PLANNING COMMISSION /
BOARD OF ZONING ADJUSTMENTS APPEAL FORM

File No.: DRH21-0010

for review and reversal of Design Review Committee approval of Addendum #2 to 2004 EIR
located at 1180 Campagna Lane, Kenwood for Kenwood Ranch Wine

RE: DRH21-0010 VOTMA Appeal from PC Action 09-07-23

IMPERVIOUS AREA MAP

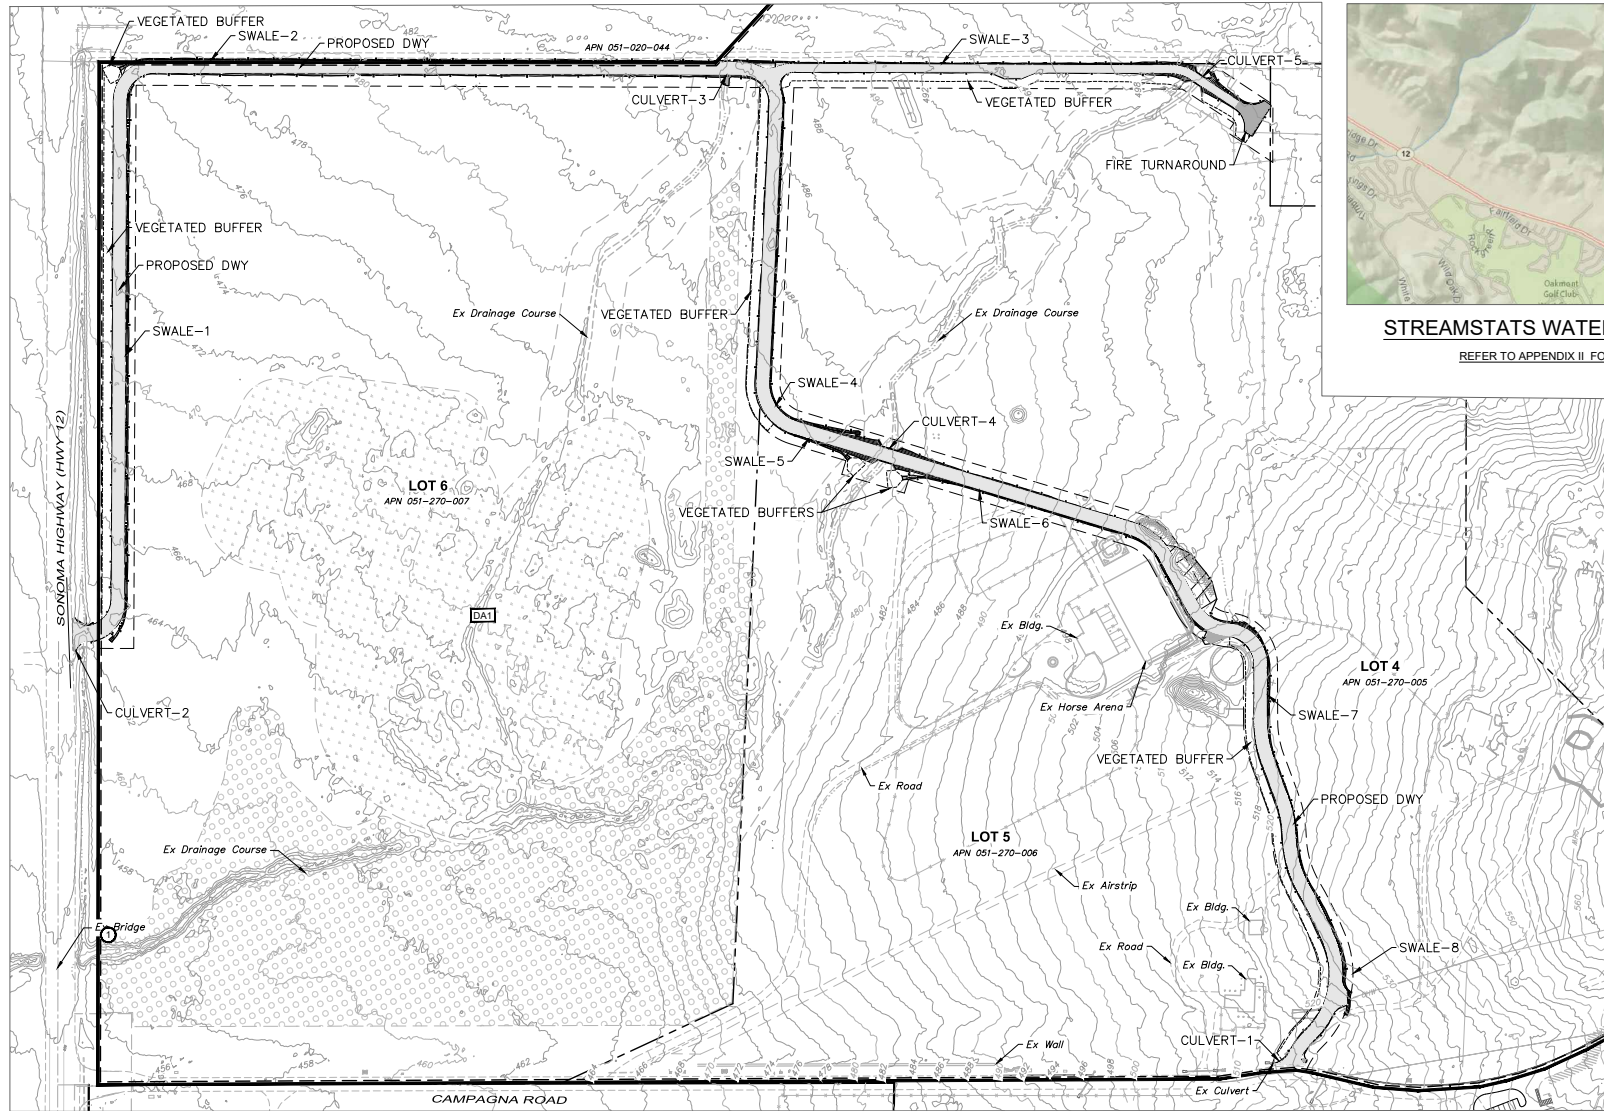
Here Addendum #2 and the I/S dodge the issue of the impacts the new proposed alternate road would have on highway 12 during an emergency evacuation. The TTAR assumes that 40% of the total traffic offsite (800-900+ people) would evacuate using the new alternate road running through the Graywood Ranch and snaking back east along Highway 12 to exit on to Highway 12 just several hundred yards west of the current Campagna exit. (Map attached)

LL03-0079/MJS01-0002 authorized creation of the 6 residence lots in the Graywood Ranch subdivision. Ingress/egress for those lots was specified to be via Campagna Lane and no other exit was authorized for development. Given this, it is hard to see the justification that there is independent utility for the road proposal, but for its use during wildfire evacuation. Clearly, Grading Permit GRD22-0174 and any other associated permits/approval for the new evacuation road should be consolidated with and incorporated into the evaluation of Addendum #2 and review of the significant effects of the proposed evacuation plan.
